Wellington City Proposed District Plan

Hearing Stream 3 – Viewshafts

Section 42A of the Resource Management Act 1991

SUBJECT: **Wellington City Proposed District Plan**
– Viewshafts Section 42A Report

Figure 4: Showing the current intrusions into ODP-VS21 with the ODP height limits.

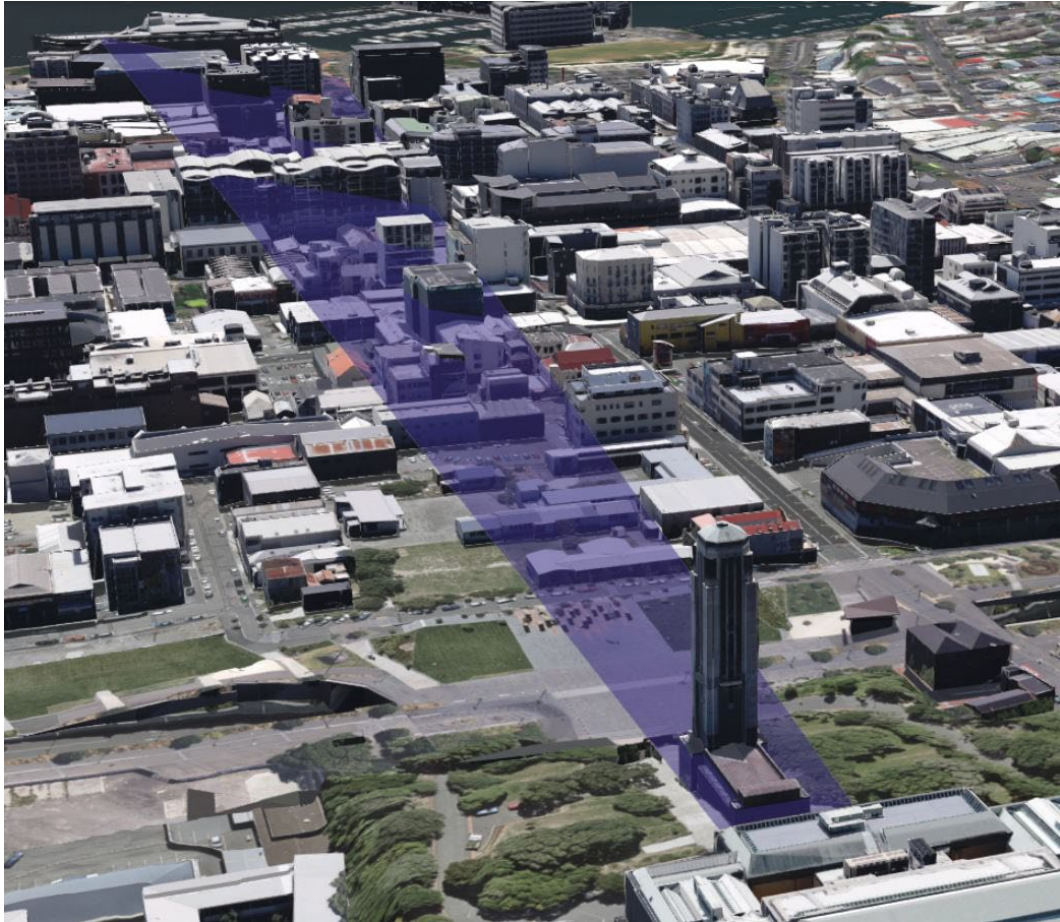
97. The 3D GIS viewer modelled the current intrusions into ODP-VS21 from the ODP building heights for the Central Area (see Figure 4 below). This shows the intrusions that in my opinion have compromised ODP-VS21 in its current form as discussed in the report⁷.

Figure 14: Showing the impacts from development (intrusions into the alternative viewshaft and shading impacts) from two different height scenarios – the first where CCZ-S6 is met and the second where CCZ-S6 does not apply and development is built to 42.5m (also shown in third picture).

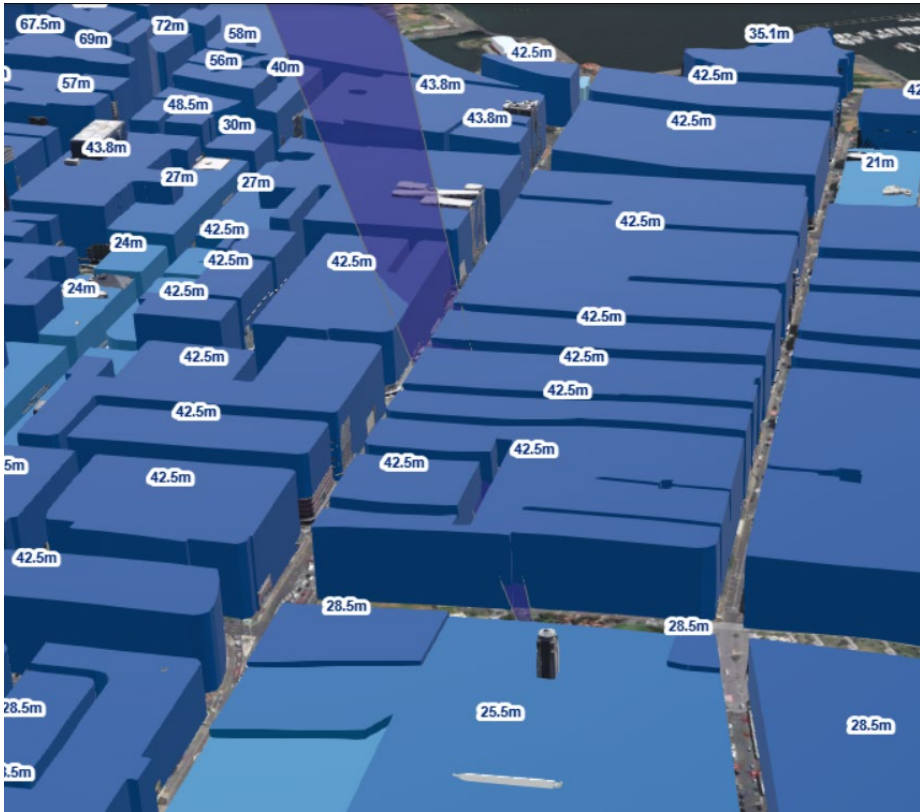
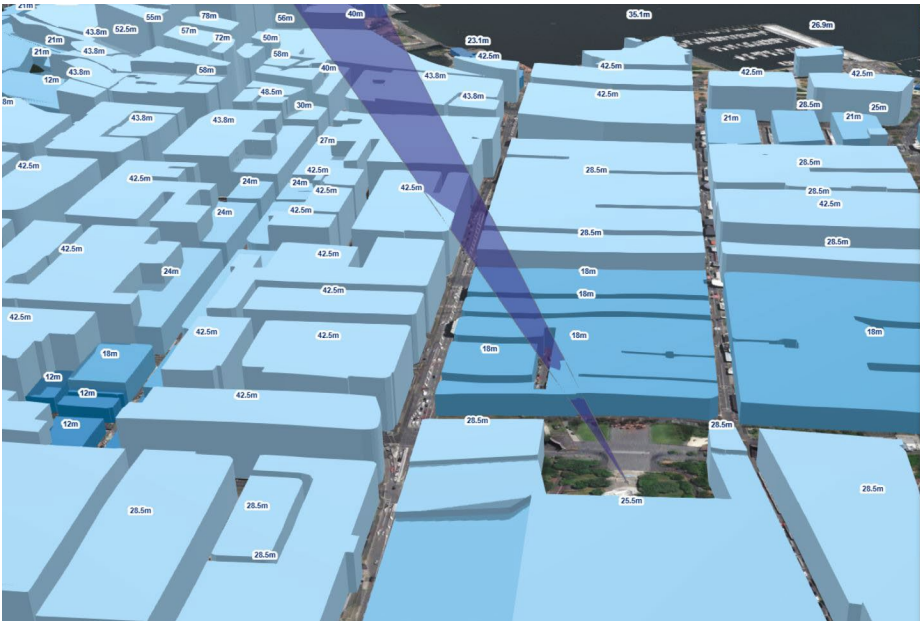
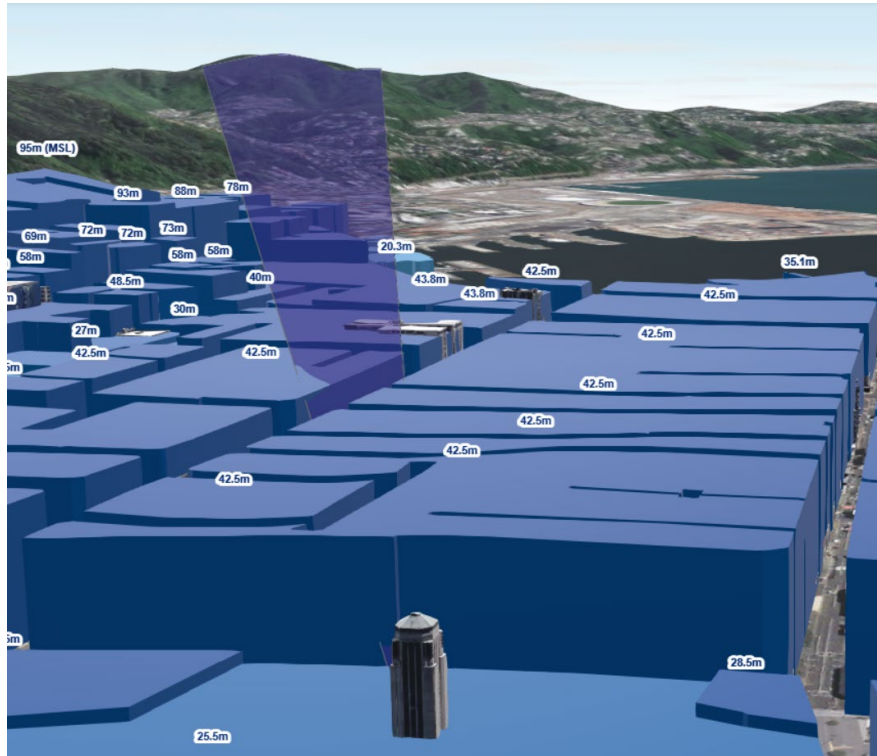
scenario (which showed 5 storeys in blocks immediately adjacent/north of the parks, then 8 storeys and then eventually 42.5m). These scenarios are shown below in Figures 14.

104. Having considered the modelling outputs for the current ODP-VS21, ODP-VS21 with heights reduced for CCZ-S6 and for the alternative viewshaft, I consider that there is benefit of including a viewshaft across Te Aro akin to ODP-VS21 but with amended margins and base information to raise the viewshaft frame up above the Century City Hotel with the focal element being the skyline of the western hills.

Figure 24: Showing the mapped proposed viewshaft and the Glenside West and Upper Stebbings Development Area.

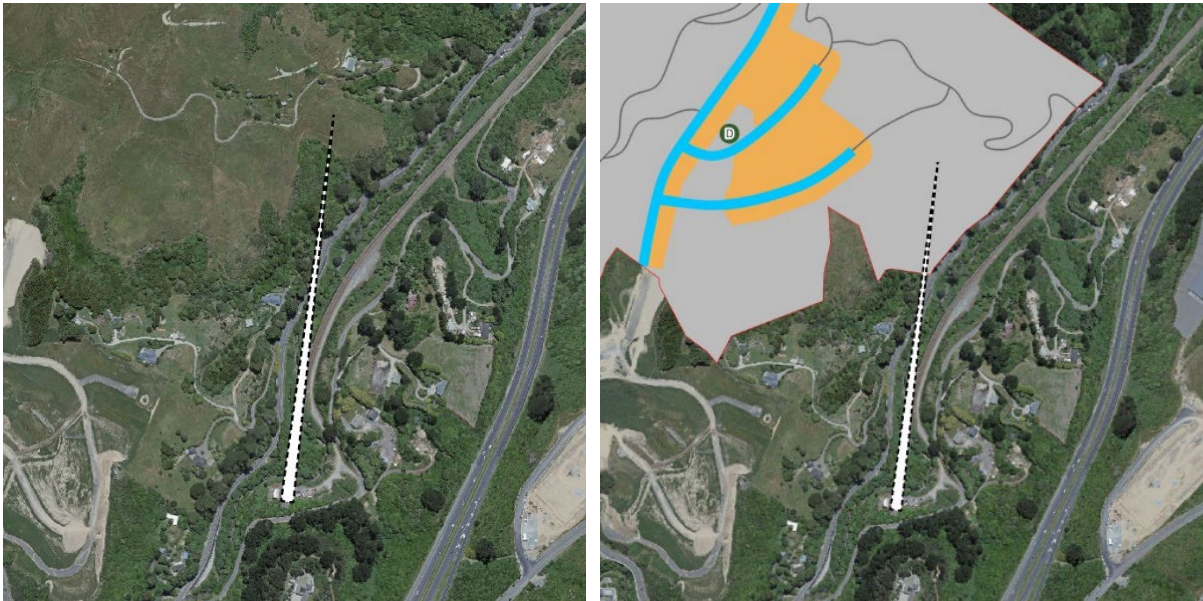
188. This development area has undertaken extensive public engagement and master planning, and this viewshaft would potentially impact the development capacity anticipated in these areas and the master planning work undertaken to date. However, I note as per the mapped viewshaft in Figure 24 below that the viewshaft appears to bisect areas labelled as 'unbuilt areas (open space, cut & fill batters)', rather than areas allocated for Medium Density Residential development. If this viewshaft was to be included in SCHED 5 it could limit development capacity in this pre-mentioned area, thus potentially undermining the Concept Masterplan work, its outputs and the community engagement undertaken by the Council to date for this development area. See Figure 24 for the mapped proposed viewshaft and its intersection through Glenside West and Upper Stebbings Development Area.

Figure 25: Showing the extension of the Viewshaft Overlay mapping to Glasgow Wharf for PDP-VS2.

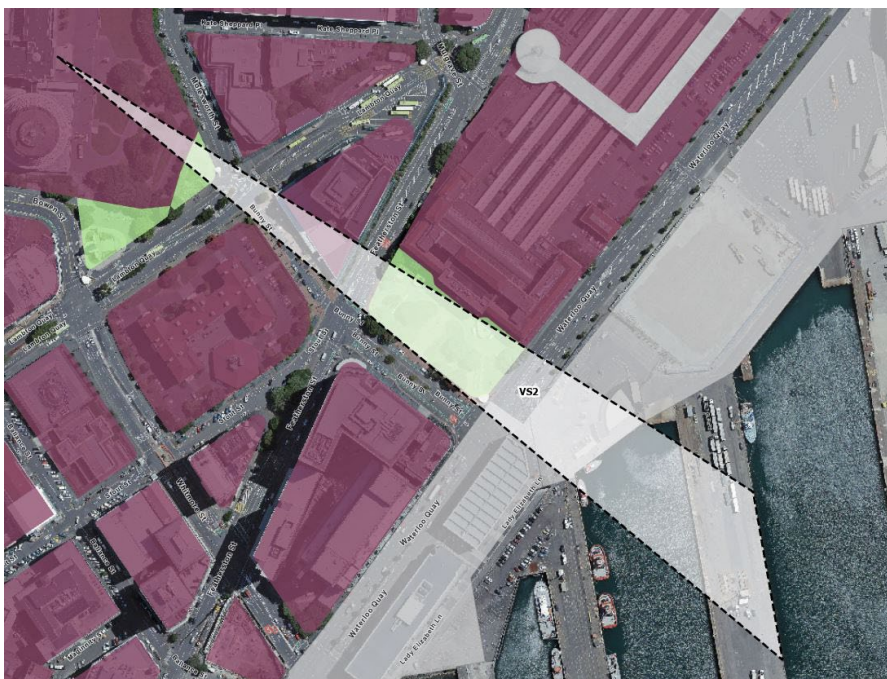
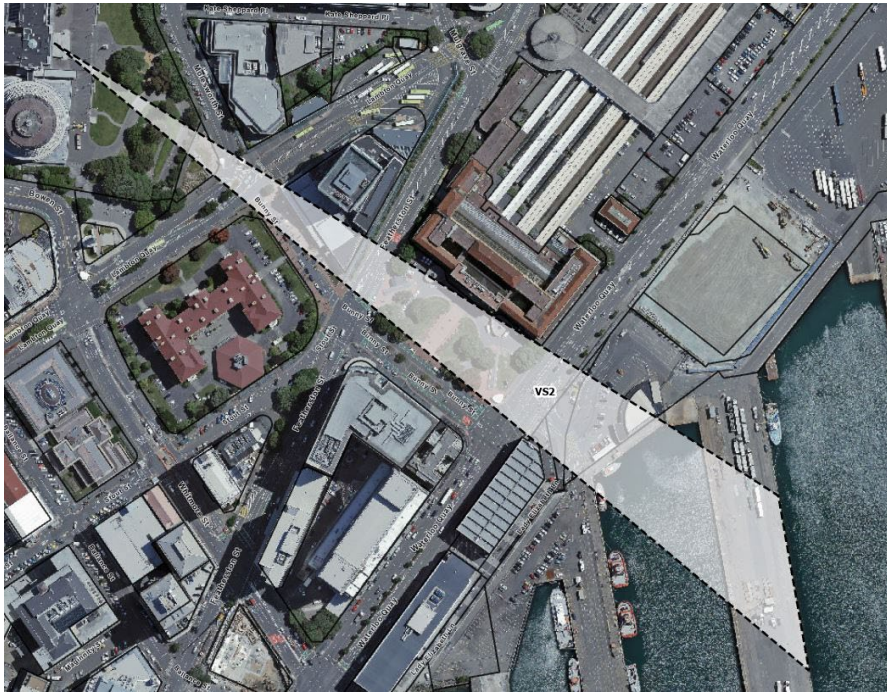
- iii. Amend PDP-VS2 as follows:
 - Move the termination point to the Eastern side of Glasgow wharf (see Figure 25).

Figure 26: Showing the extension of the Viewshaft Overlay mapping to Oriental Parade for PDP-VS3.

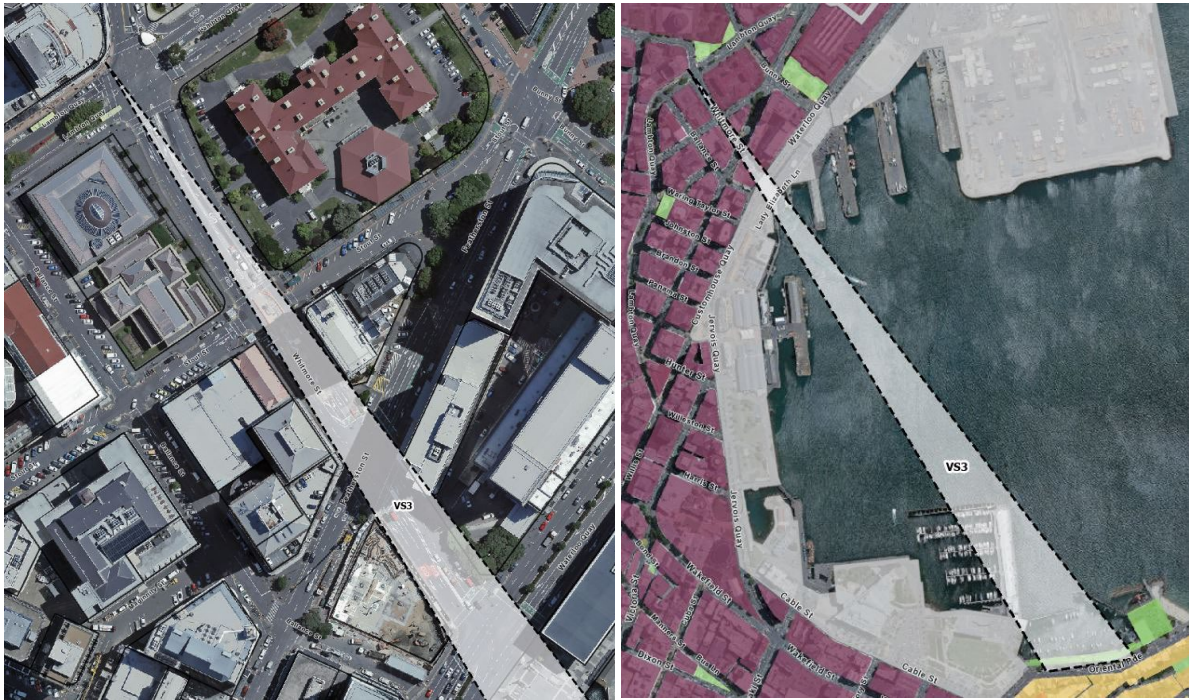
- iv. Correct PDP-VS3 as follows:
 - Move the termination point so that it extends to the northern road edge of Oriental Parade (see Figure 26).

Figure 28: Showing the extension of the Viewshaft Overlay mapping to Oriental Parade for PDP-VS6.

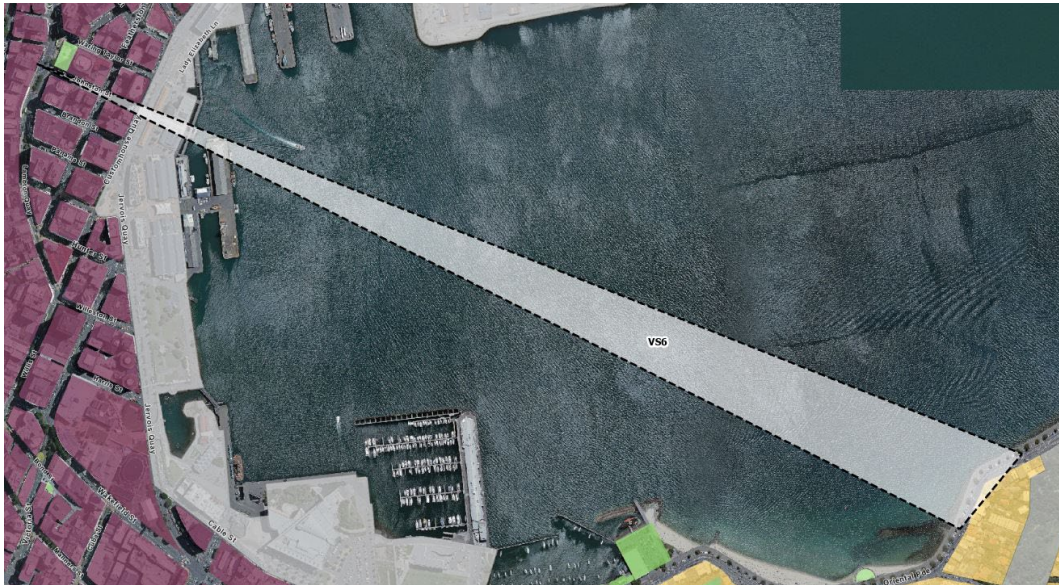
- Move the termination point so that it extends to the northern road edge of Oriental Parade (see Figure 28).

Figure 30: Showing the extension of the Viewshaft Overlay mapping to St Gerard's Monastery for PDP-VS11 to align with SCHED5 and correction of the left margin.

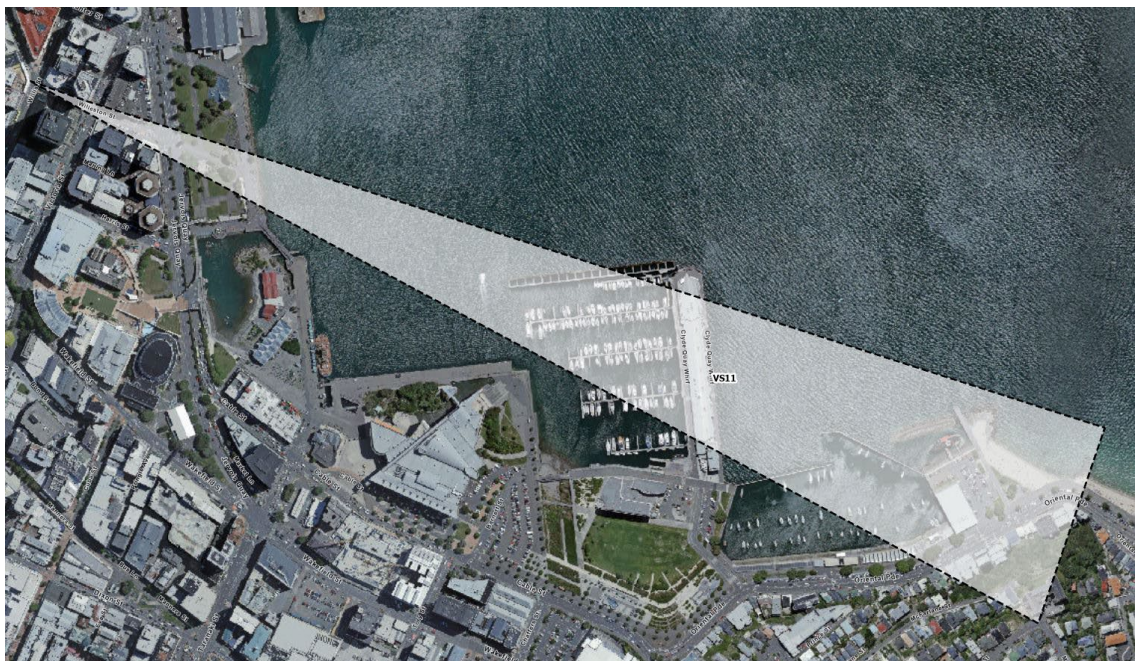
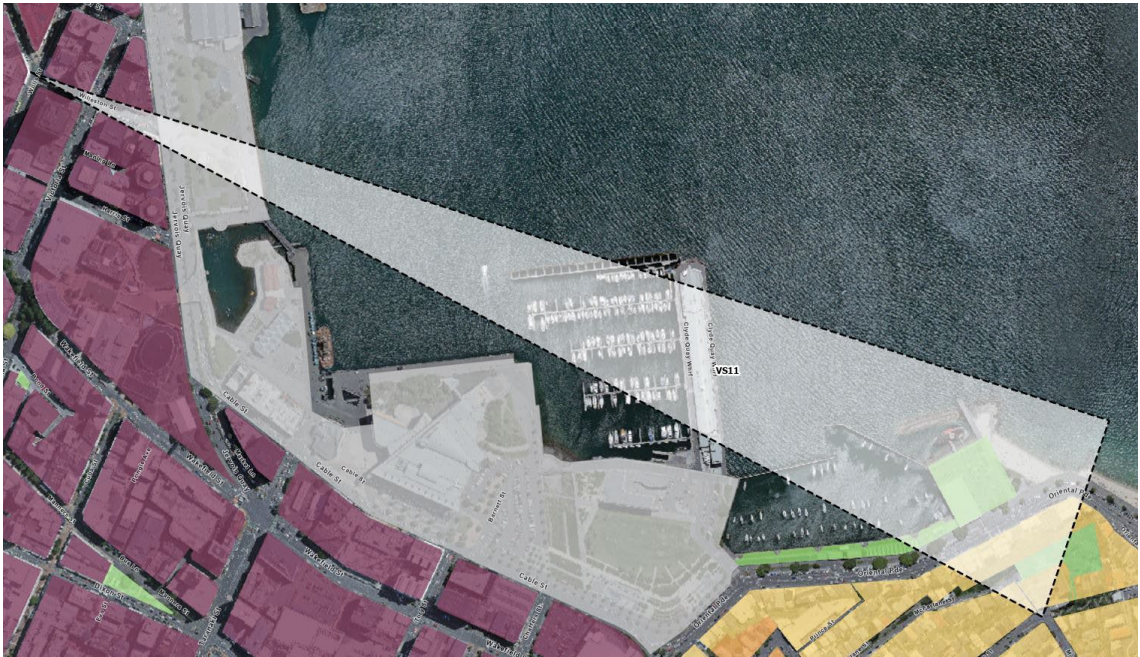
- xi. Amend PDP-VS11 as follows:
- Amend the extent to include St Gerard’s Monastery (see Figure 30).
 - Correct the left margin to intersect at the southern corner of 22 Willeston Street and the right margin to intersect at the north eastern corner of the tower element of 5 Willeston Street (see Figure 30).

Figure 31: Showing the extension of Viewshaft Overlay mapping to St Gerard's Monastery for PDP-VS12 to align with SCHED5.

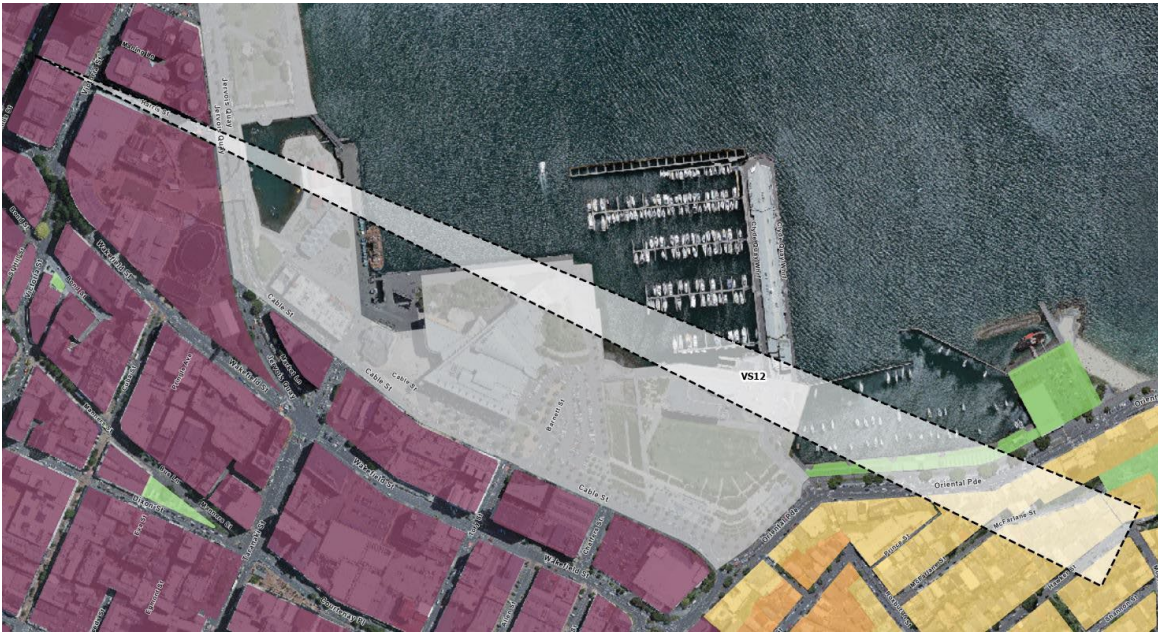
- xii. Amend PDP-VS12 as follows:
- Correct the left margin to align with the location described in SCHED5 – Viewshafts (see Figure 31).
 - Amend the extent to include St Gerard's Monastery (see Figure 31).

Figure 32: Showing the amended left and right margins of PDP-VS13 to align with SCHED5.

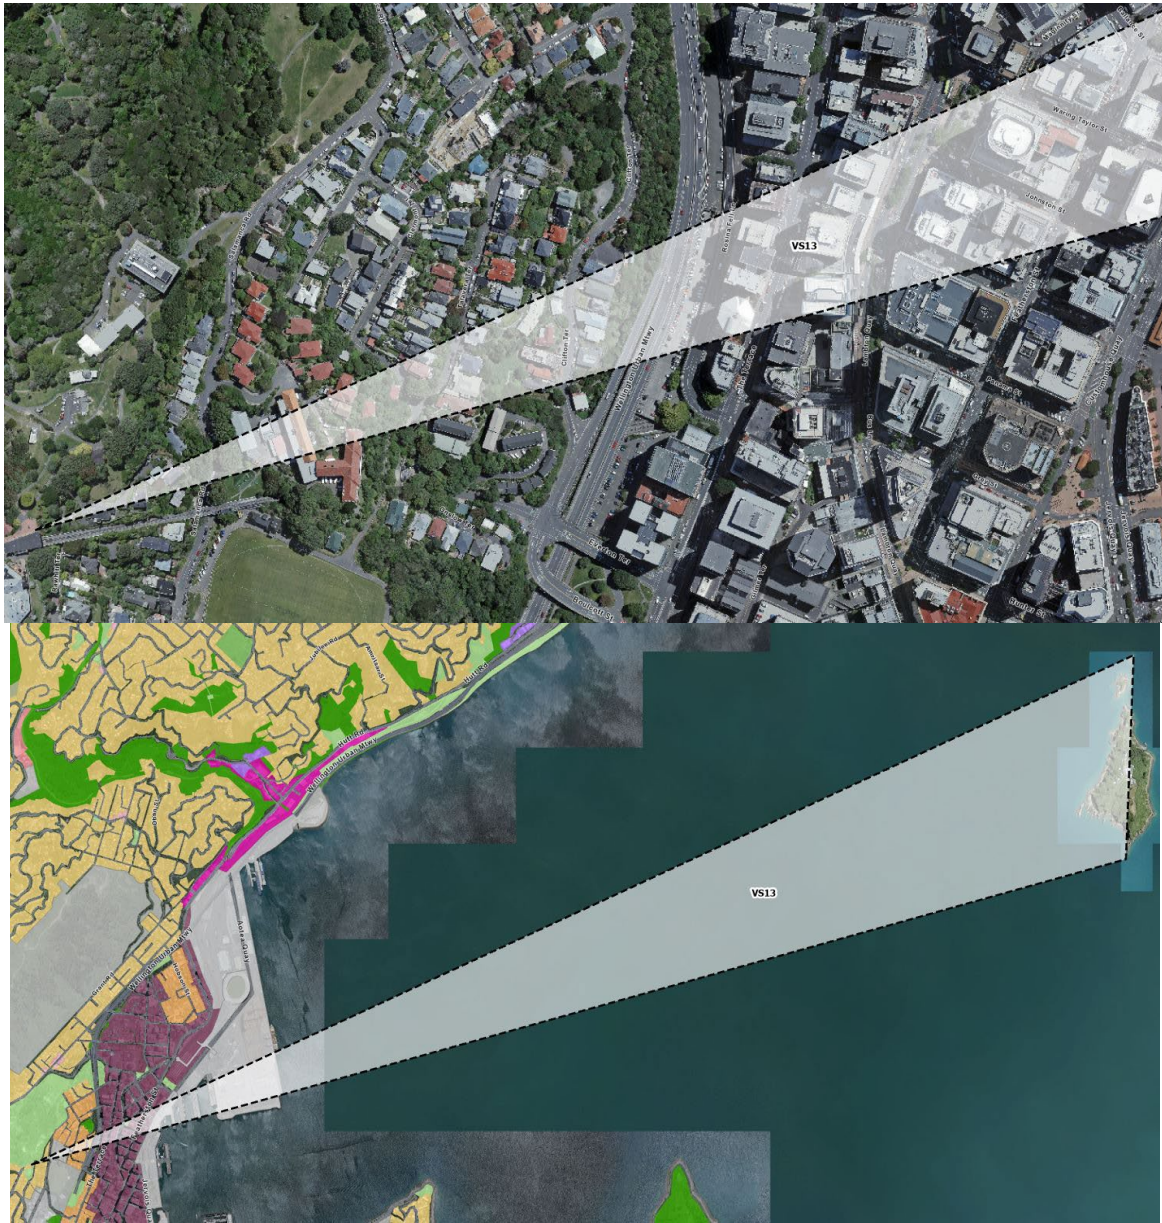
- xiii. Correct PDP-VS13 to widen the left margin to include the rocks to the north of Mokopuna Island and the right margin to include the rocks to the south of Matiu Somes Island (as per the description in SCHED5), see Figure 32.
